Tennessee Valley Authority, 1101 Market Street, Chattanooga, TN 37402

CNL-17-095

Clinch River Nuclear Site  
NRC Docket No. 52-047

Subject: Submittal of Supplemental Information Related to the Environmental Audit in Support of Early Site Permit Application for Clinch River Nuclear Site

**Figure 2.3.2-5  
 Individual Well Locations Within a 1.5-mile Radius of the CRN Site**

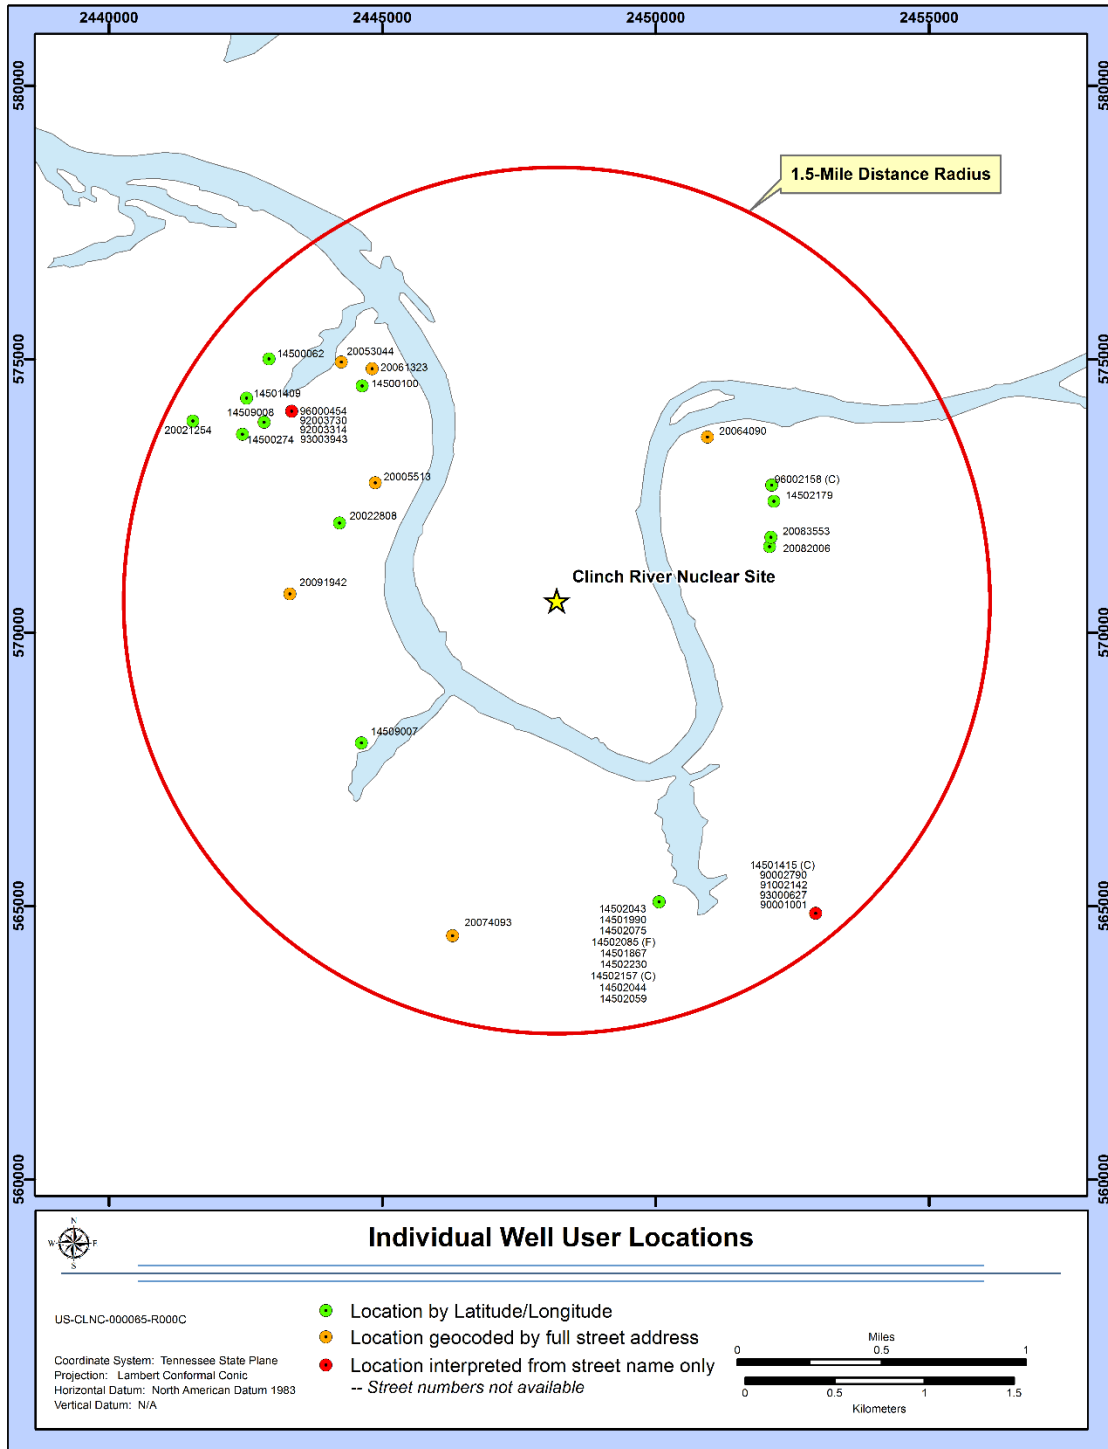
During the groundwater discussion at the environmental audit, the NRC staff requested that TVA provide supplemental information regarding individual groundwater wells in the vicinity of the CRN Site. Therefore, supplemental information addressing individual groundwater users within a 1.5-mile radius of the CRN Site is being added including, a new paragraph at the end of ER Section 2.3.2.2.2, new ER Table 2.3.2-7, and new ER Figure 2.3.2-5.

ER Figure 2.3.2-5 (new figure) is being added as indicated.

**Figure 2.4.1-7**  
**Individual Well Locations Within a 1.5-mile Radius of the CRN Site**

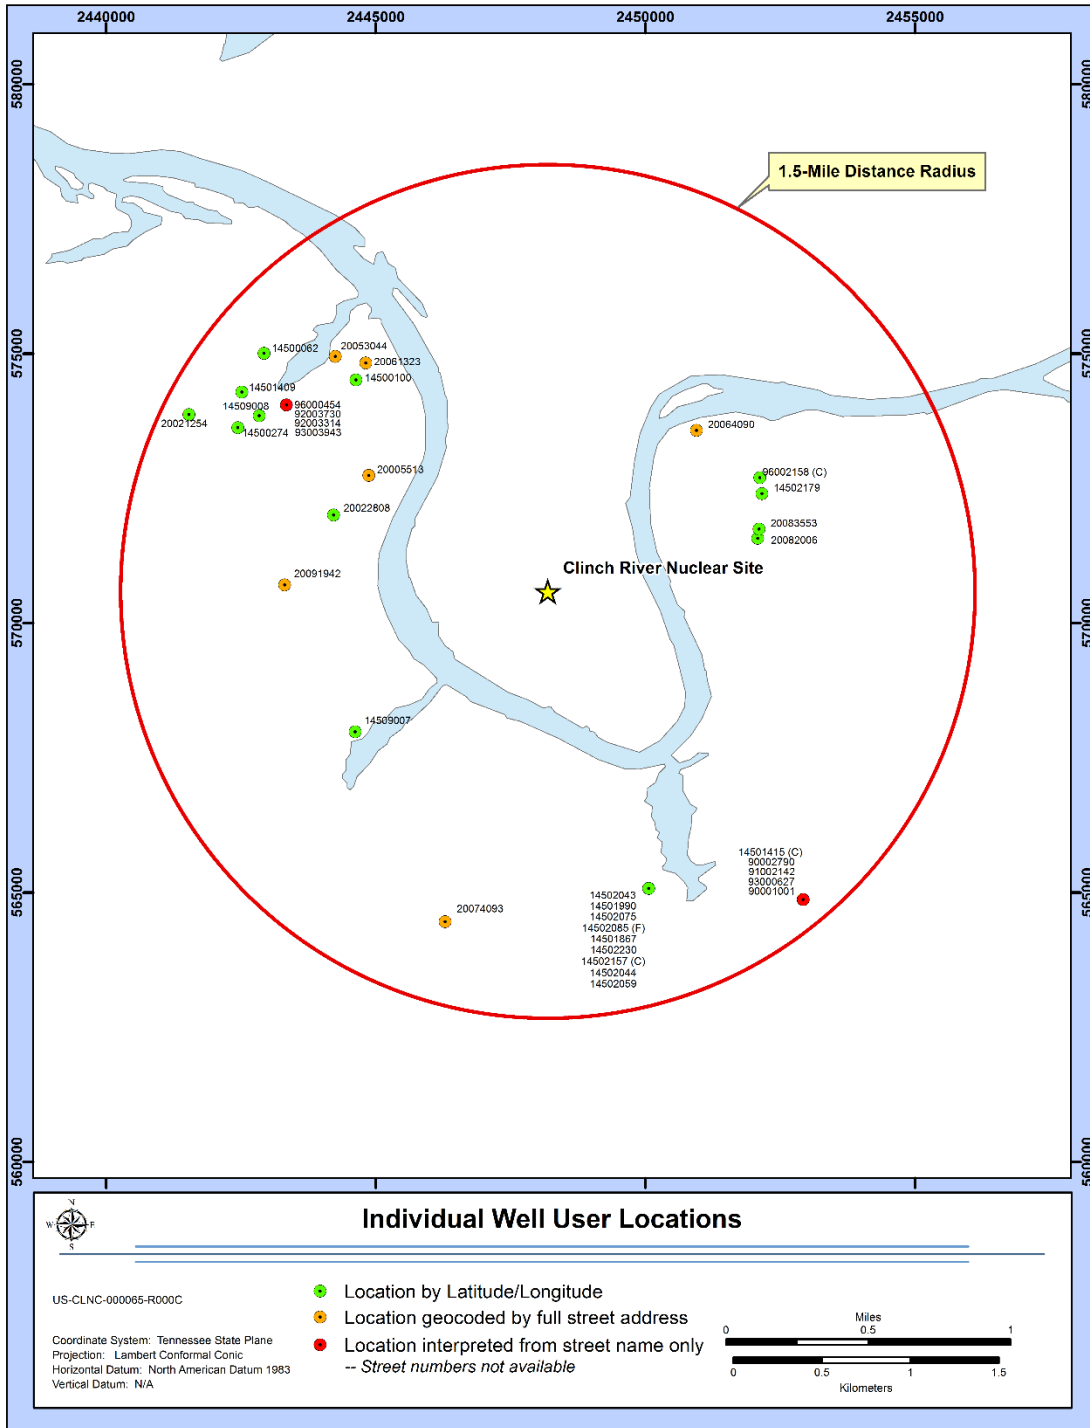
Also, during the groundwater discussion at the environmental audit, TVA was requested to provide supplemental information for individual groundwater users in the vicinity of the CRN Site to address INs 01e and 23. Therefore, supplemental information addressing individual groundwater users within a 1.5-mile radius of the CRN Site is being added including, a new paragraph at the end of SSAR Subsection 2.4.1.2.2, new SSAR Table 2.4.1-5, and new SSAR Figure 2.4.1-7.

SSAR Figure 2.4.1-7 (new figure) is being added as indicated.
